MASTER DEVELOPMENT DRAINAGE PLAN

CROSSROADS NORTH

EL PASO COUNTY, COLORADO

Project #18-001
PCD Project #SP 20-207

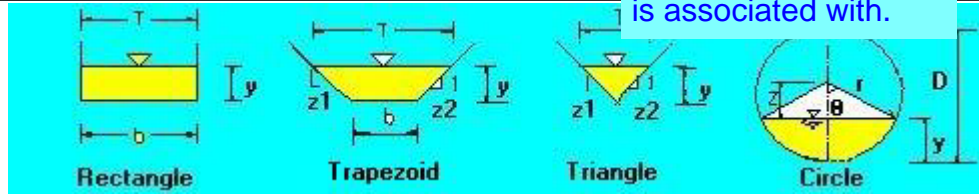
label and reference on the drainage map. Not sure which drainage channel this is associated with.

Upstream Capacity at Design Point 27

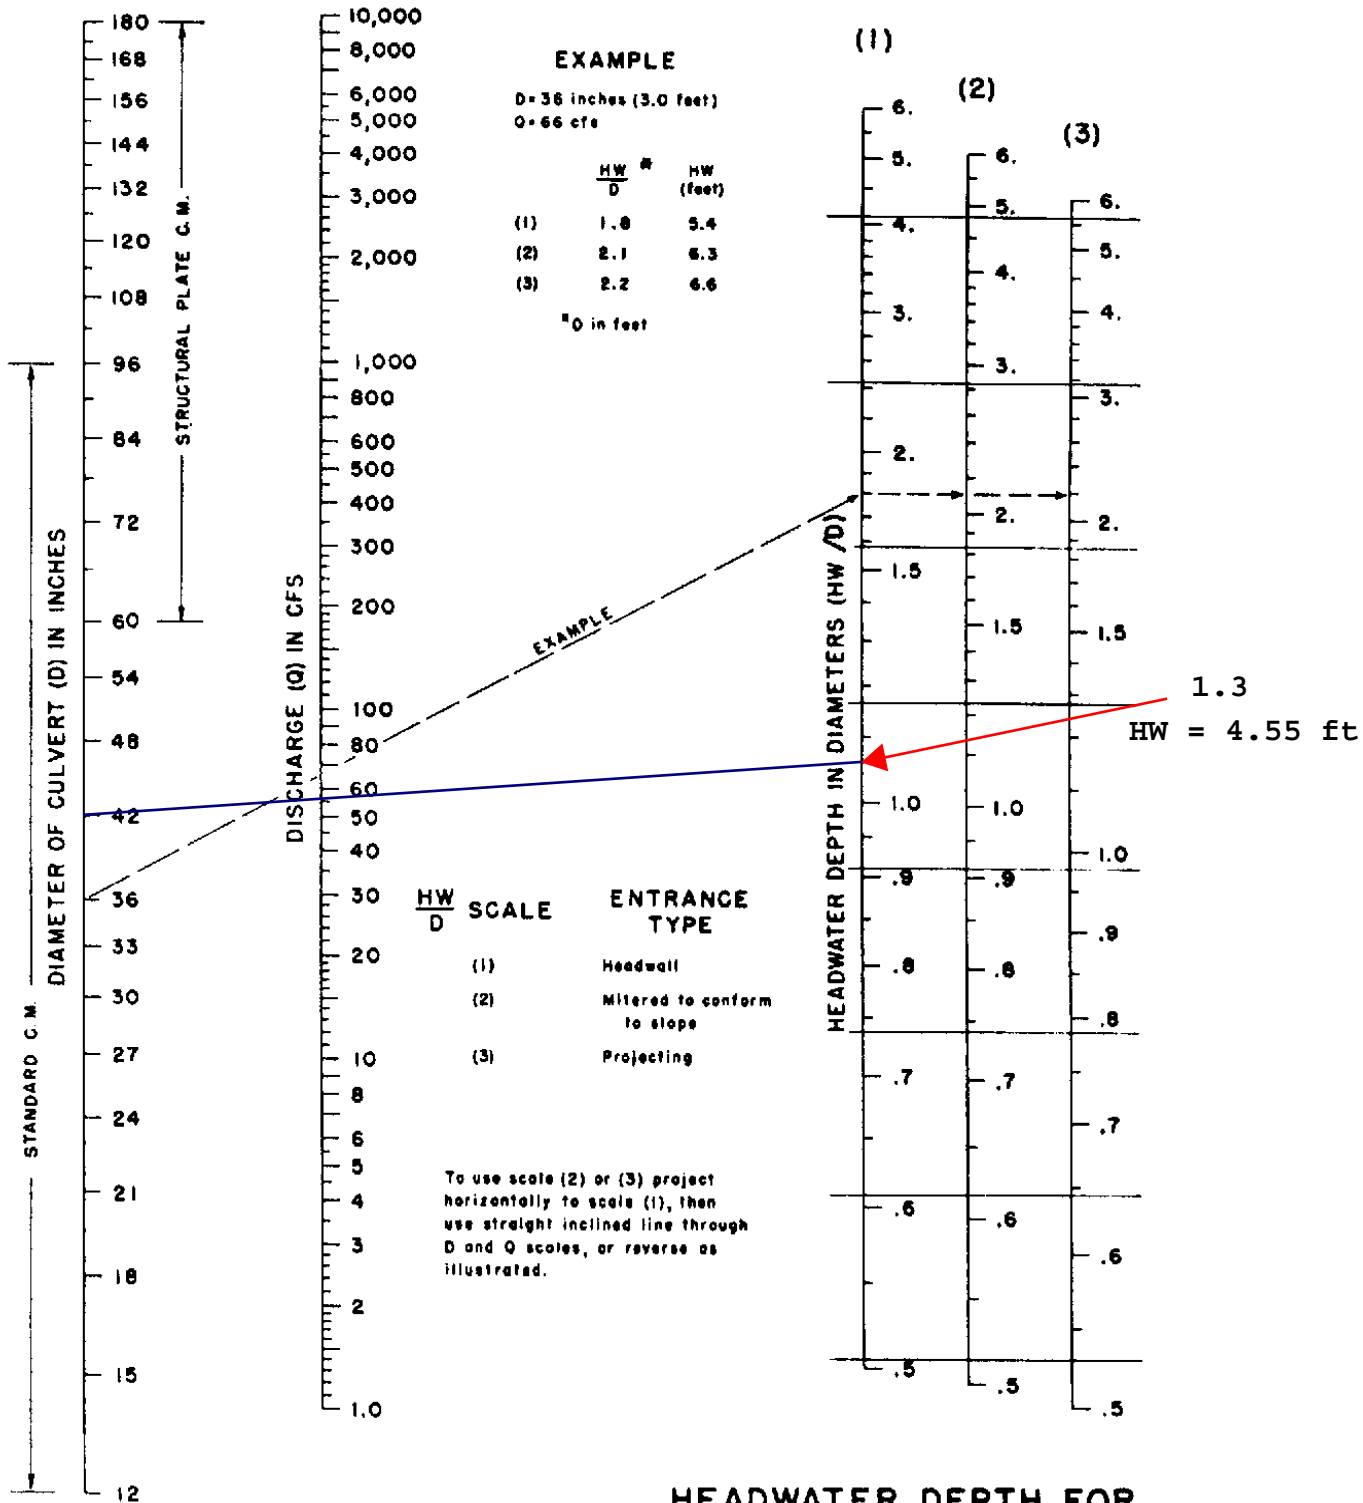
Getting the flow into the pipe may require significantly higher headwater depth. Add at least 1.5 times the velocity head to get the headwater depth or [see my 2-minute tutorial](#) for standard culvert headwater calculations using HY-8.

CROSSROADS NORTH PROPOSED DRAINAGE MAP
DATE SUBMITTED: 03/24/2022
SHEET 1 OF 1

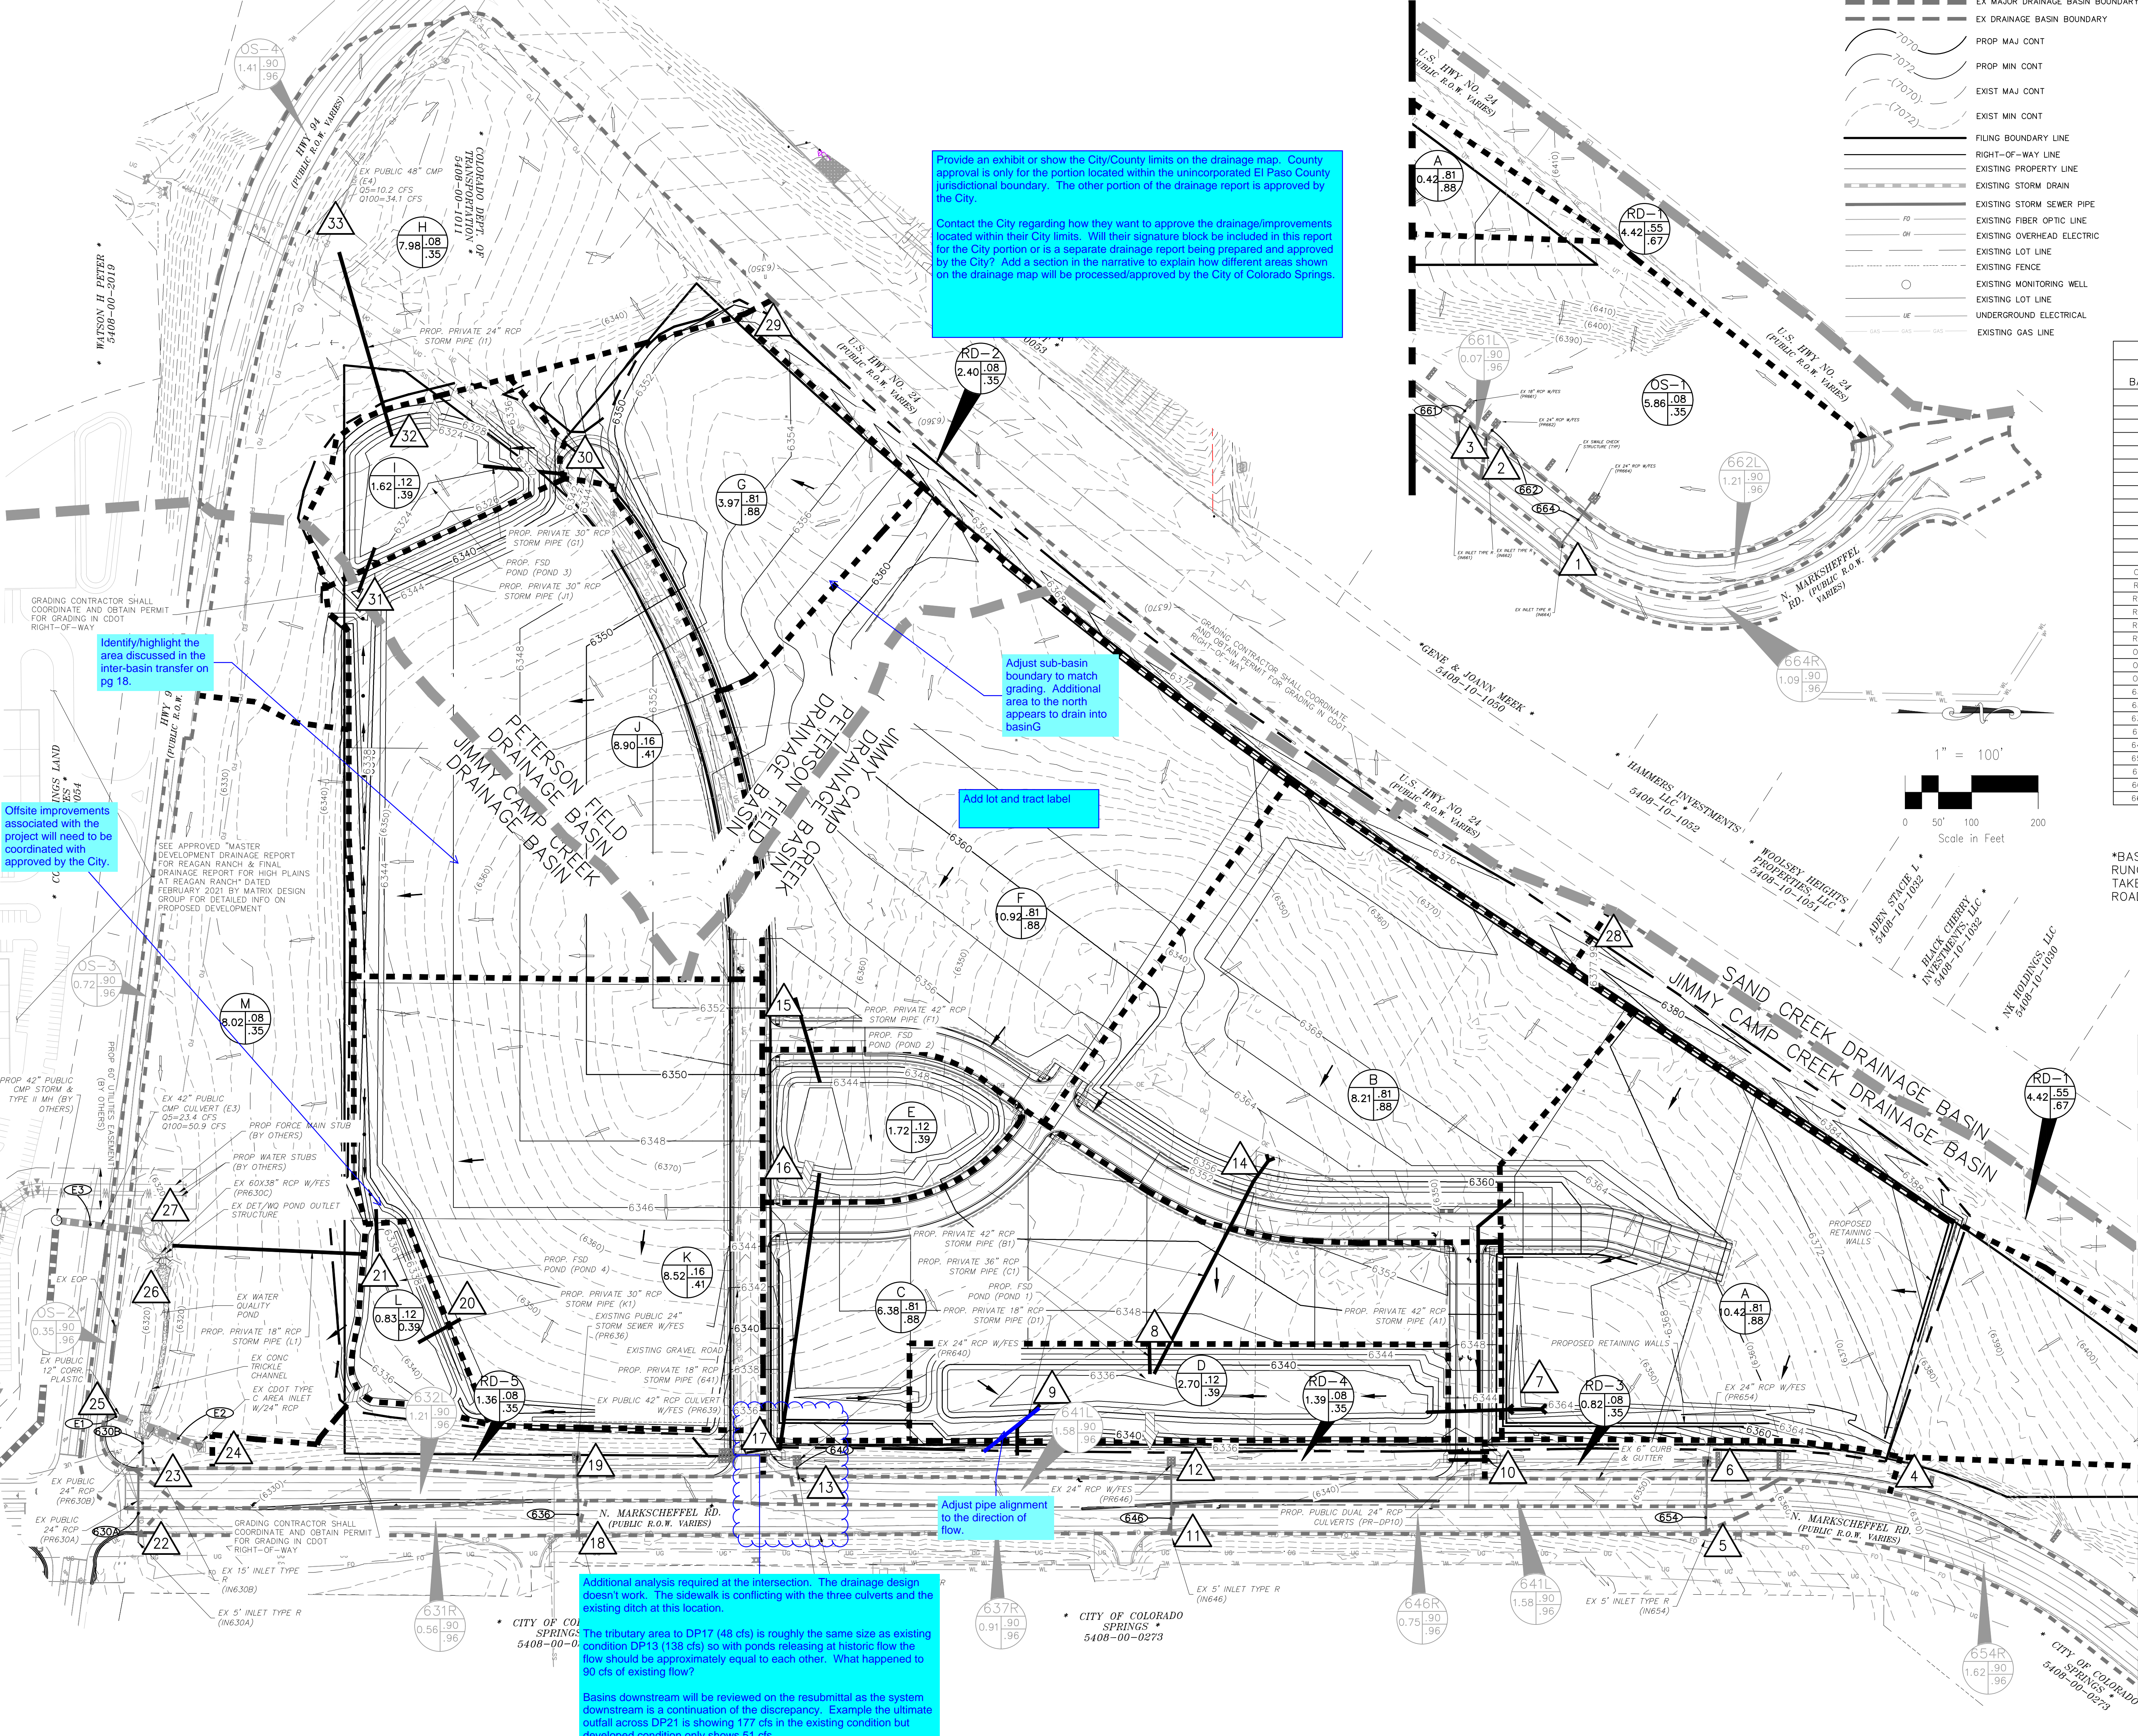
Provide an exhibit or show the City/County limits on the drainage map. County approval is only for the portion located within the unincorporated El Paso County jurisdictional boundary. The other portion of the drainage report is approved by the City.

Contact the City regarding how they want to approve the drainage/improvements located within their City limits. Will their signature block be included in this report for the City portion or is a separate drainage report being prepared and approved by the City? Add a section in the narrative to explain how different areas shown on the drainage map will be processed/approved by the City of Colorado Springs.

Identify/highlight the area discussed in the inter-basin transfer on pg 18.

Add lot and tract label.

Move leader to point to correct area.

Show missing contours throughout plans.

Design point 5 description states existing pipe is 24". Revise.
